Dynamic Information Migration

June 2011

VM migration reference diagram

Associate/Deassociate in diagram

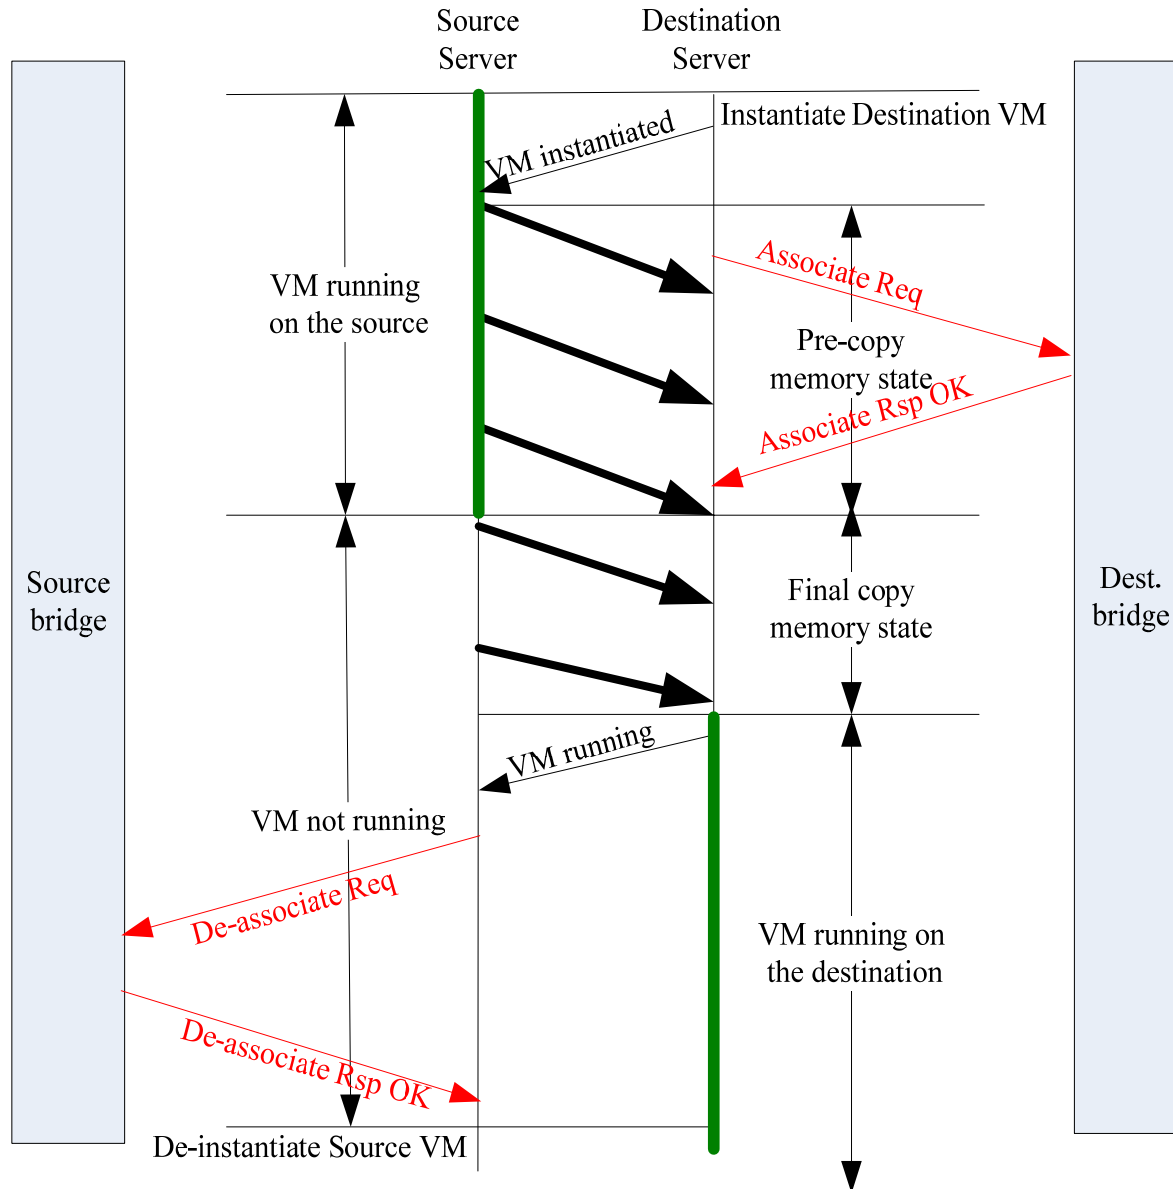
Or? (minor point)

De-instantiate of source VM should not occur until after de-associate completes???

Are Association and VM Instantiation are not necessarily related

Associate should not be requested until VM has been instantiated??

Again, I don't think this is necessary.

Mike Krause suggestion to serialize

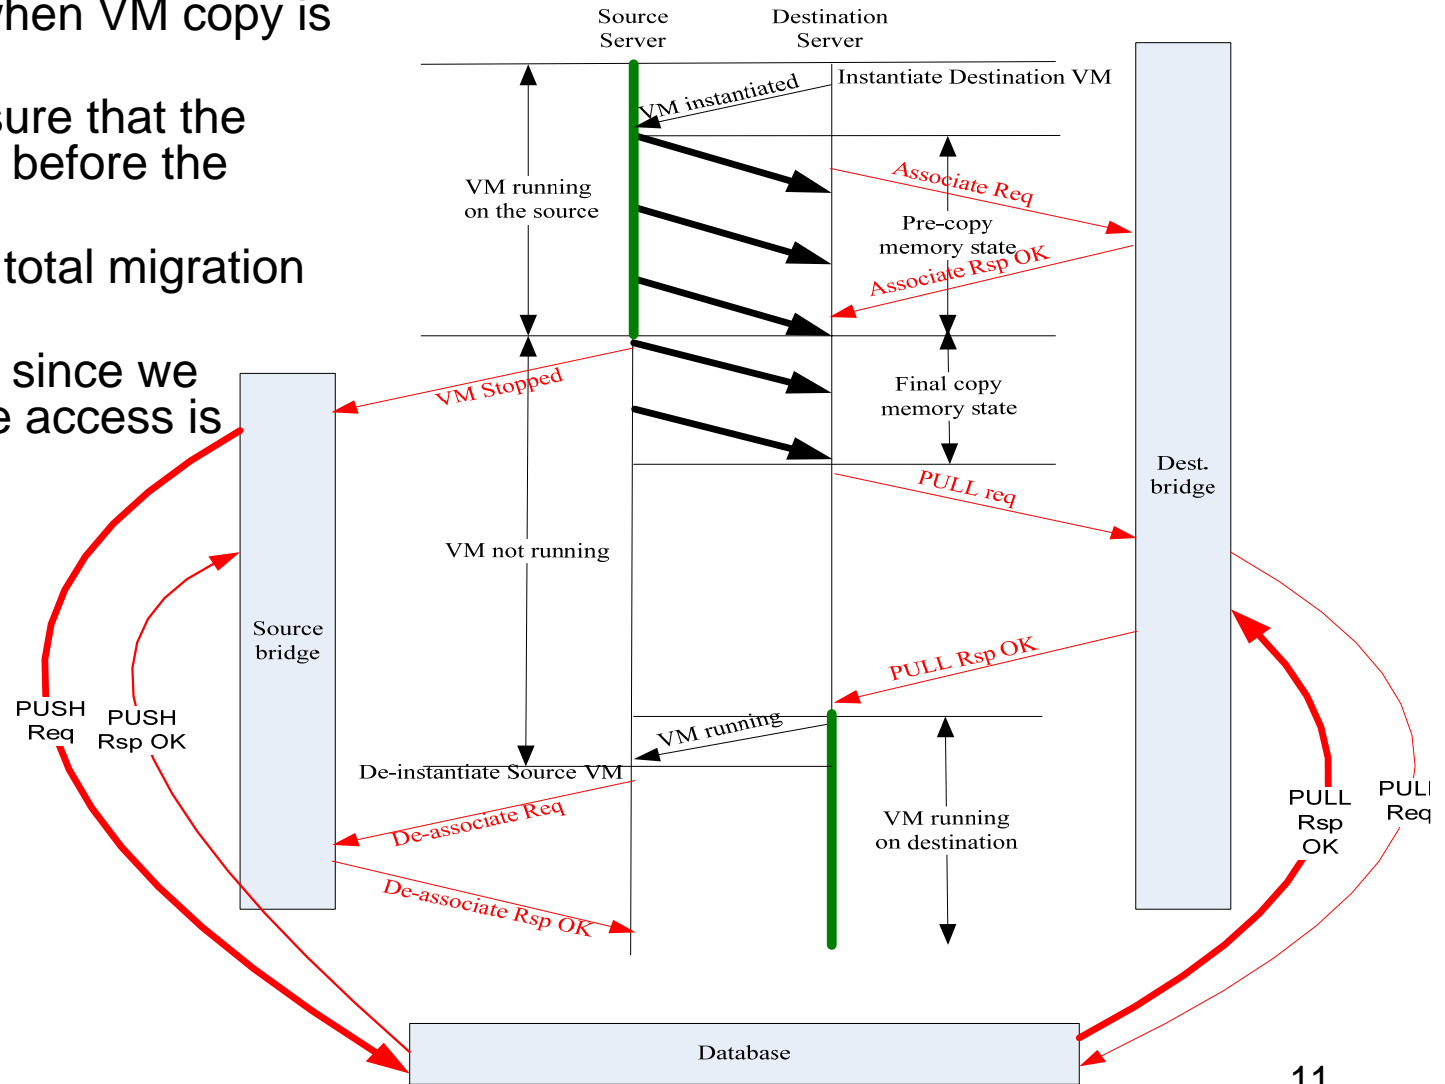
- PUSH triggered when Source VM stops;
- PULL triggered when VM copy is complete???
- Purpose is to ensure that the PUSH completes before the PULL???
- Results in longer total migration time;
- Benefit isn't clear since we assume database access is asynchronous;
